NORTHEAST UTILITIES

Millstone Nuclear Power Station, Unit No. 3
Structural and Geotechnical
Engineering Branch
Additional Information in Response
to Confirmatory Items

Attachment I

Revised Responses to Structural Audit Items:

ACCELERATION
 4.00
 3.33
 2.67
 2.00
 1.33
 0.67
 0.00

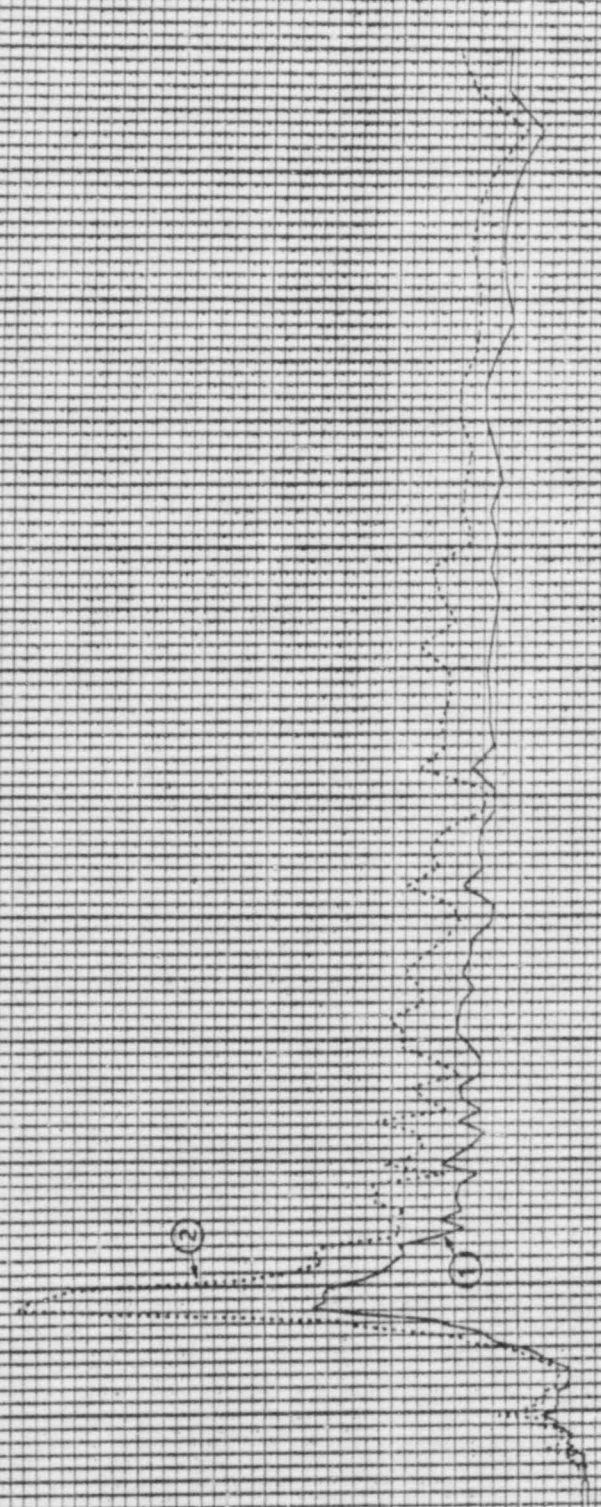
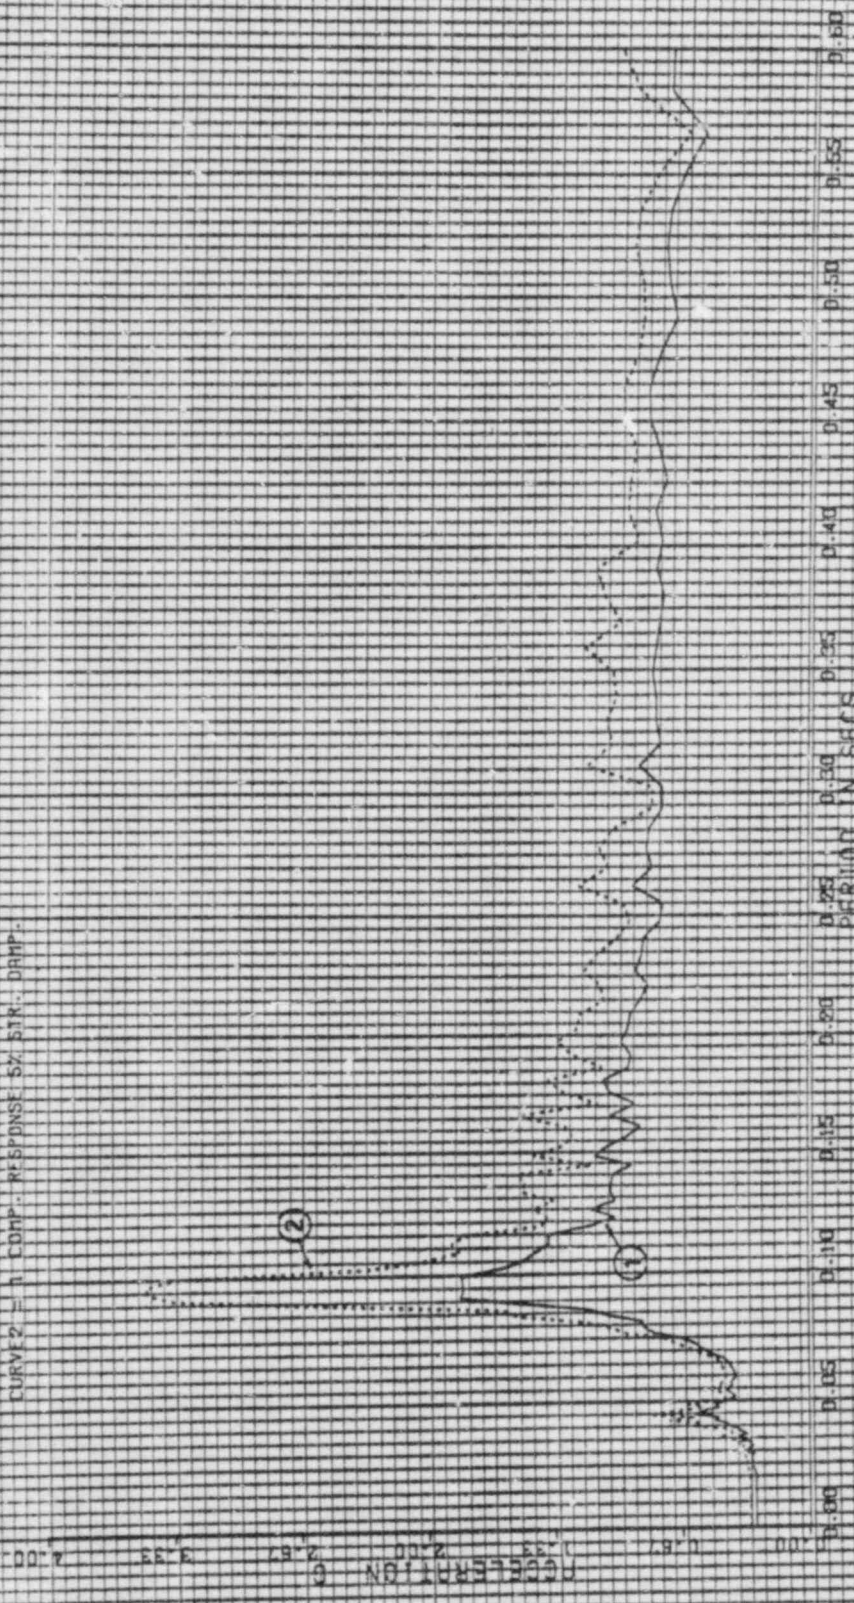
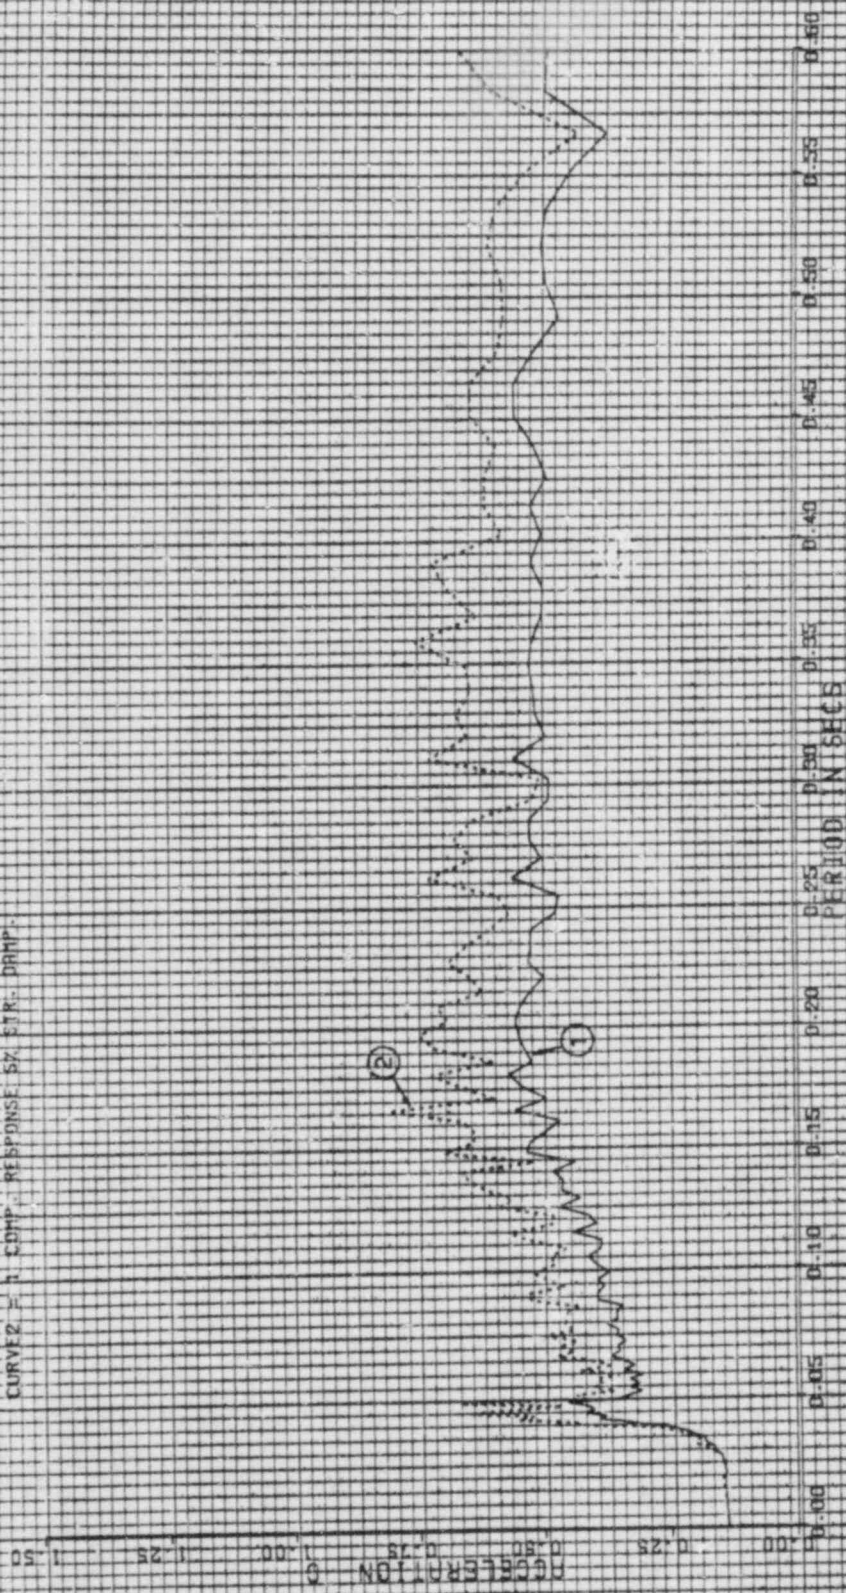
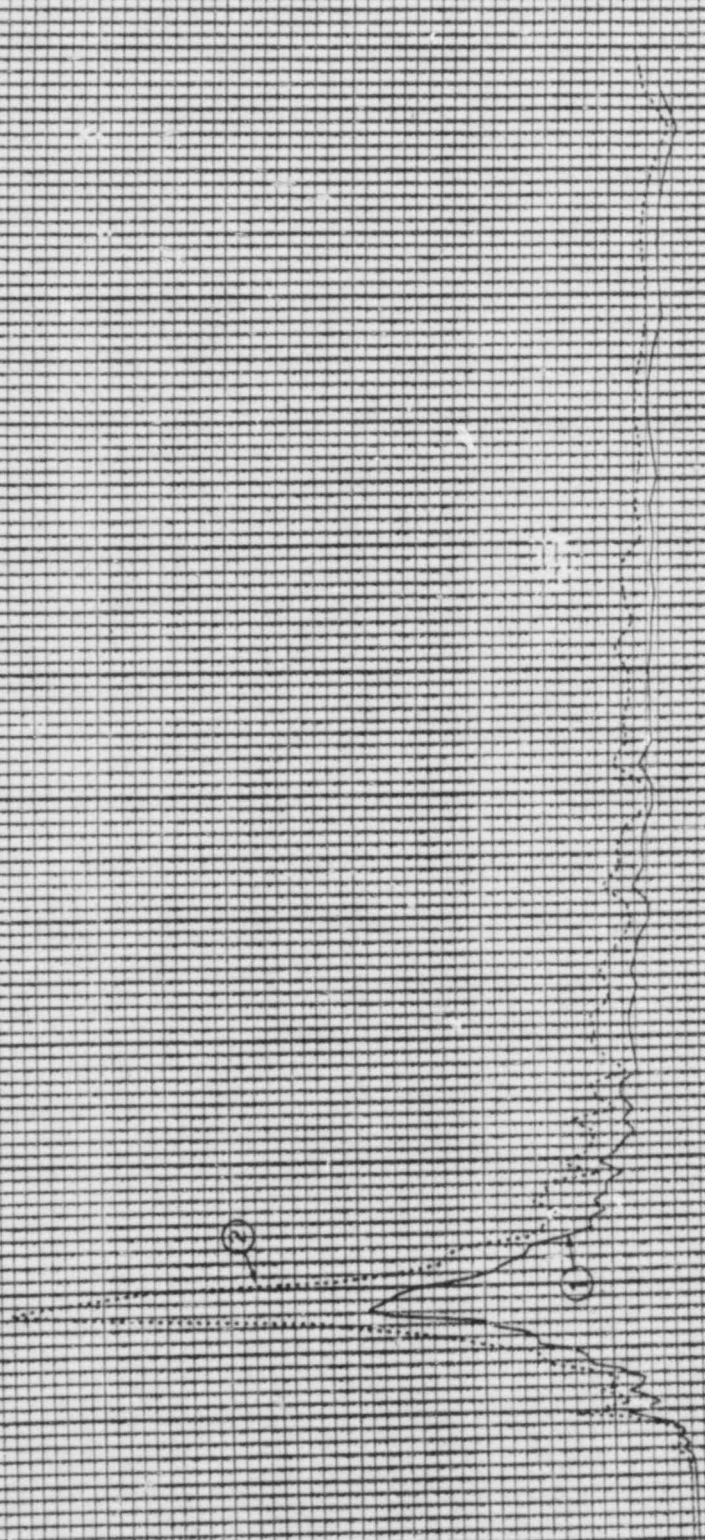
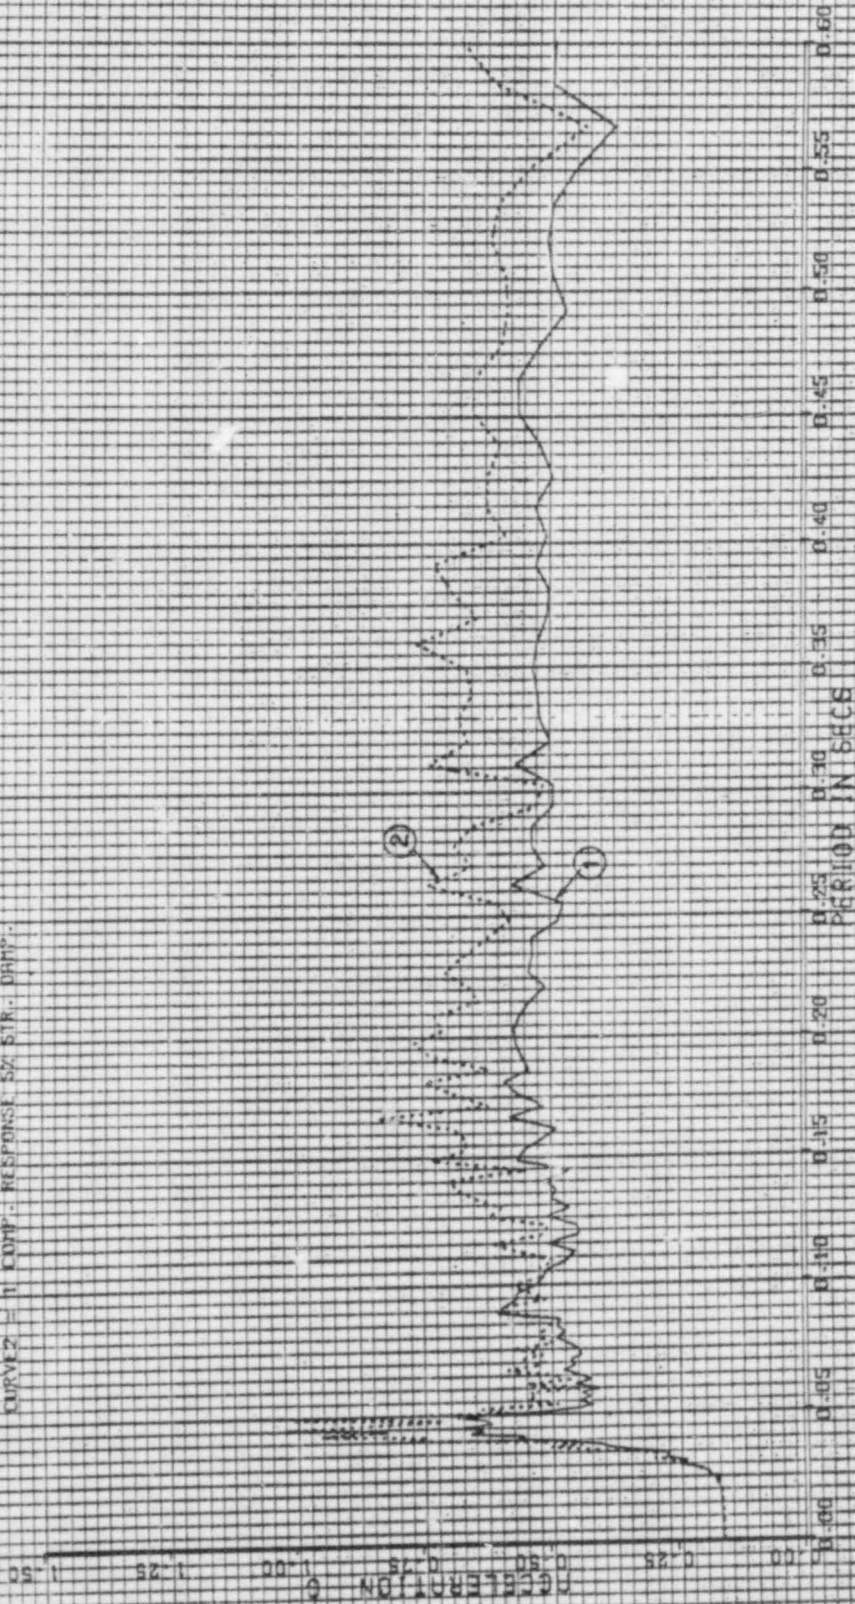
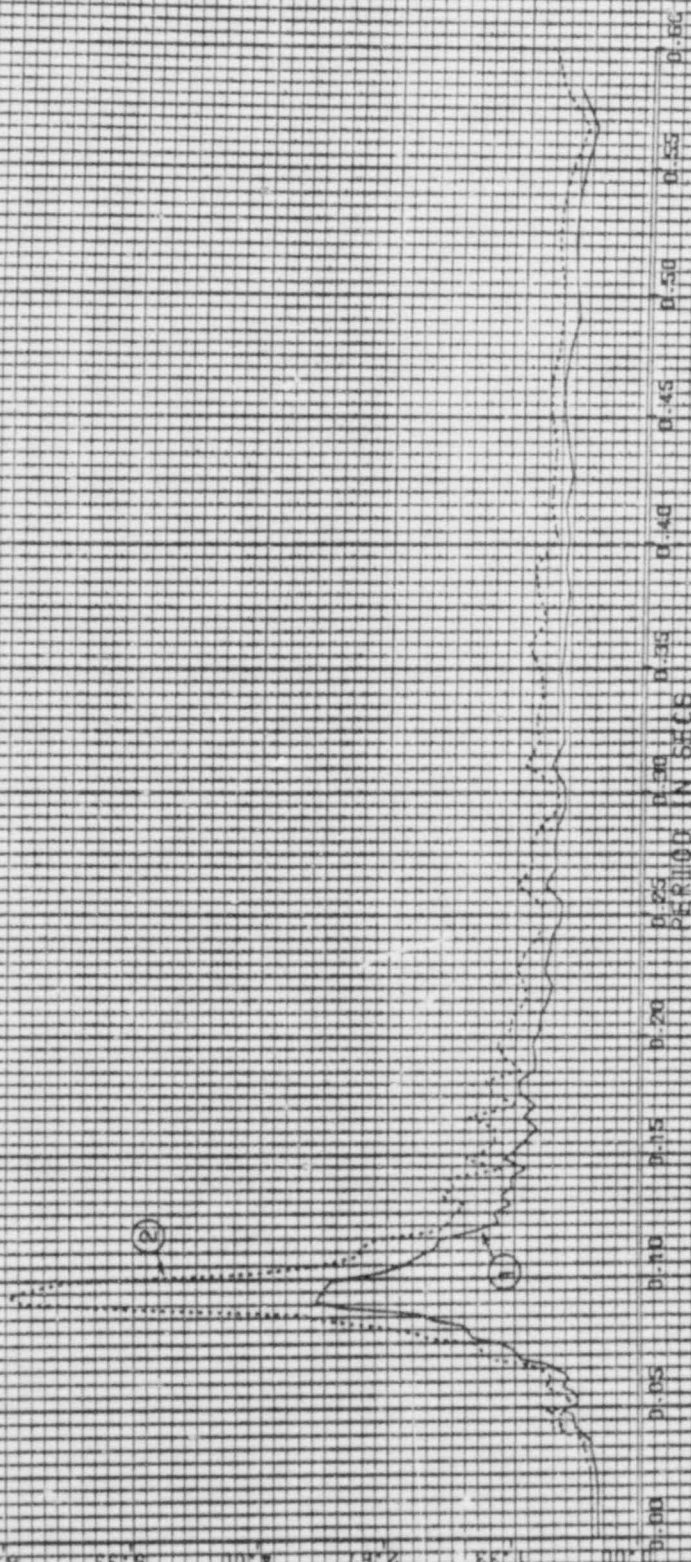
ITEM 27: Provide Justification for Generation of ARS Based Upon One
- Component of Input Motion

The method and criteria used in the generation of ARS for Millstone Unit 3 are inherently conservative. Conservative damping values are used both for structures and equipment. The conservatism in those damping values can be seen when they are compared with the recognized conservative values in Regulatory Guide 1.61. In addition, the input time history used to generate the ARS envelopes the design response spectrum as shown on Figures 3.7B-3 through 3.7B-8 of the FSAR.

To evaluate the conservatism of the one-component ARS curves, a study was conducted to provide a comparison between ARS developed for the SSE condition using:

1. One-component response with 5 percent structural damping and 1 percent oscillator damping.
2. Three-component response (SRSS of the three ARS components) with 7 percent structural damping and 2 percent oscillator damping.

To assure a study representative of all Category I buildings, the Containment Structure, Auxiliary Building, and Fuel Building were evaluated. The Auxiliary Building is representative of all Category I buildings with little coupling, and the Fuel Building is representative of buildings with a large degree of coupling. In every case, the ARS were generated for SSE condition using the three-component response and are enveloped by the response spectra that have been used in piping and equipment qualification.

The attached amplified response spectra curves used in the study are provided for the above buildings in the direction of E-W, N-S and vertical excitation are as follows:

Therefore, it is concluded that the one-component ARS curves developed for all Millstone Unit 3 Category I buildings are conservative with respect to the three-component ARS curves.
